CHARTER TOWNSHIP OF VAN BUREN PLANNING COMMISSION AGENDA Wednesday, June 9, 2021 – 7:30 PM REMOTE MEETING –AGENDA

ITEM # 1:	CASE 19-038 CAMPING WORLD – PRELIMINARY AND FINAL SITE PLAN AMENDMENT APPROVAL	
TITLE:	THE APPLICANT, DERRICK MATTER / CAMPING WORLD IS SEEKING AMENDED PRELIMINARY AND FINAL SITE PLAN APPROVAL TO AMEND A PREVIOUSLY APPROVED FINAL SITE PLAN BY RENOVATING THEIR EXISTING BUILDING IN PLACE OF DEMOLISHING A PORTION OF THE BUILDING, AND REDUCING THE PROPOSED SIZE OF A REDEVELOPED RV PARKING AND STORAGE AREA ON THE SITE.	
LOCATION:	The site is located at 43646 North Interstate Service Drive (tax parcel number 83 060 01 000: 001), on the north side I- 94 North Service Drive, between Dewitt and Morton Taylor Roads.	
ACTION ITEMS:	A. Presentation by the Township Staff.B. Presentation by the applicant.C. Planning Commission discussion.

ITEM # 1: CASE 21-008 – KALITTA AIR LLC

Subject: VBT-19-038 Camping World/ 43646 I-94 N. Service Drive; Amended Site Plan Review #1;

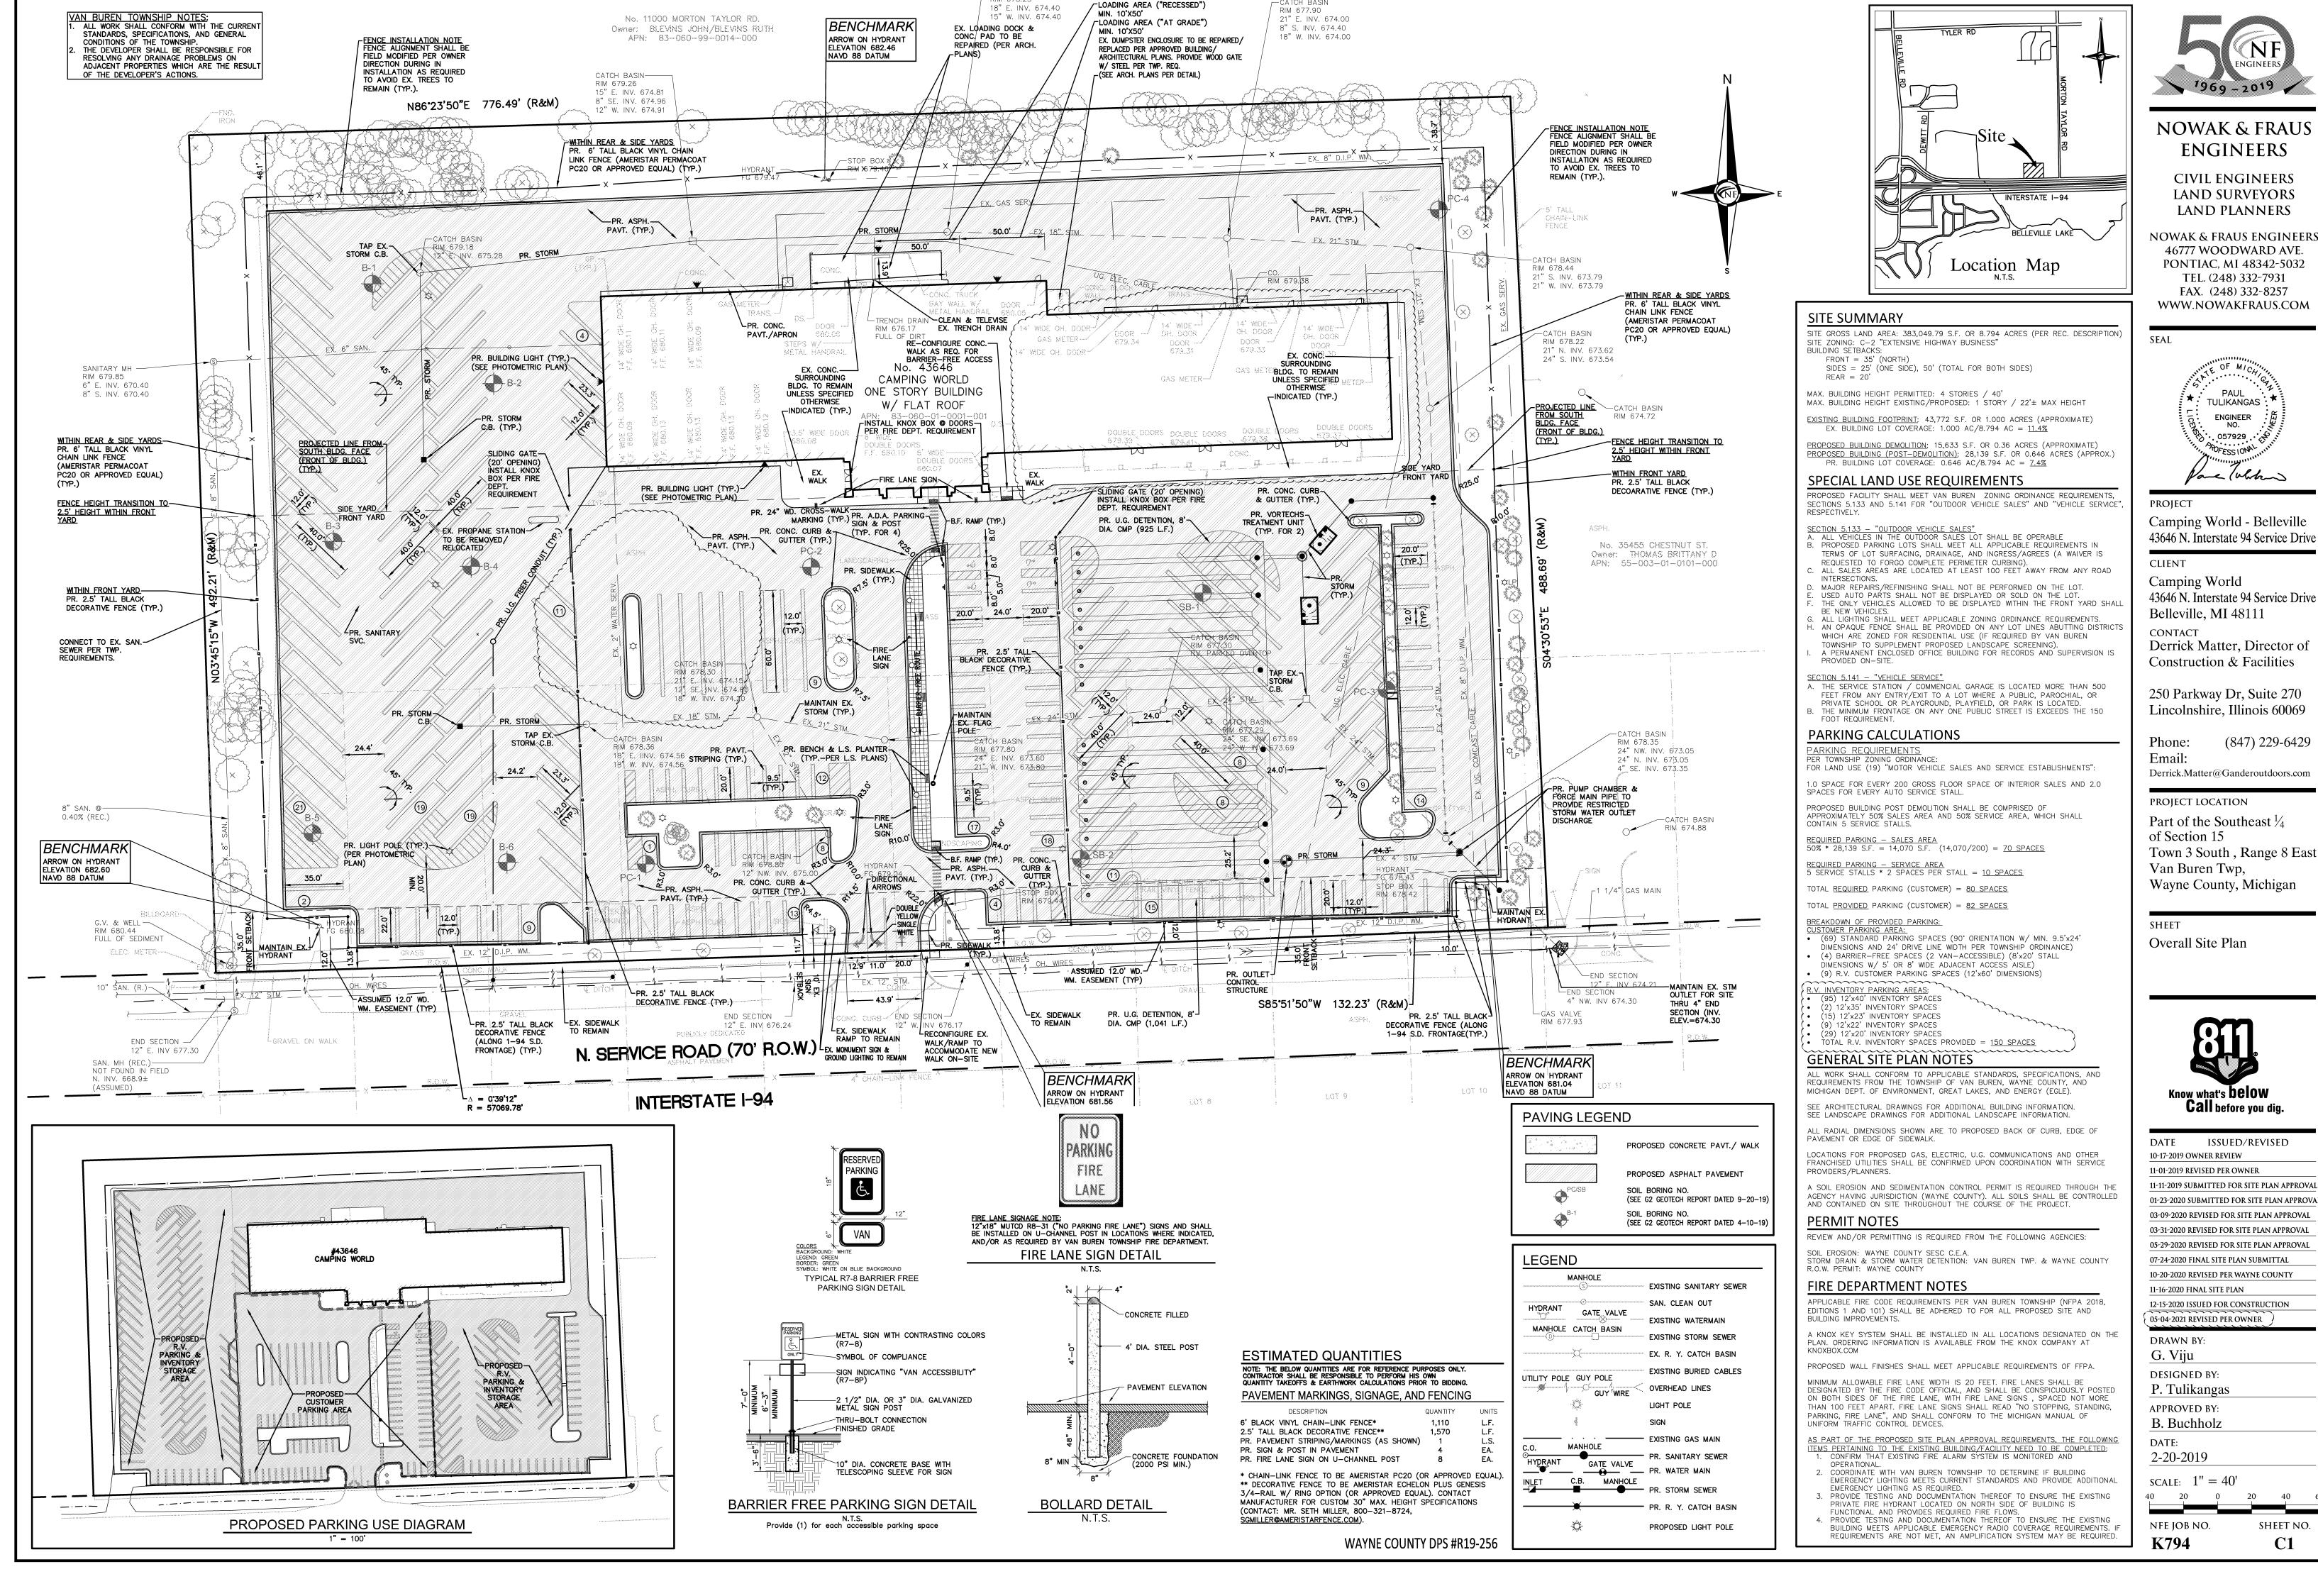
A description of the proposed use and the amount of floor area allocated to each proposed use in the proposed new building should be described...

Information regarding maximum staffing at peak shift...

- The new addition to the Kalitta Air Training Center (new building) that is being proposed will be primarily used for the training of all flight crews (both initial new hire and recurrent training).
- The new 55,241 square foot building will house the following...
 - 3 Flight Simulators
 - o 2 briefing rooms for each flight simulator (total of 6)
 - o 6 classrooms that will be primarily used for ground school training
 - o A computer room used to house the required equipment to run the flight simulators
 - 3 small offices
 - 1 large office
 - o 1 large open office space on the 3rd floor

- Full time Personnel (Ground Instructors/Administrative) There are currently 8 employees.
 There will not be any additional full time staffing added with the addition of the new building.
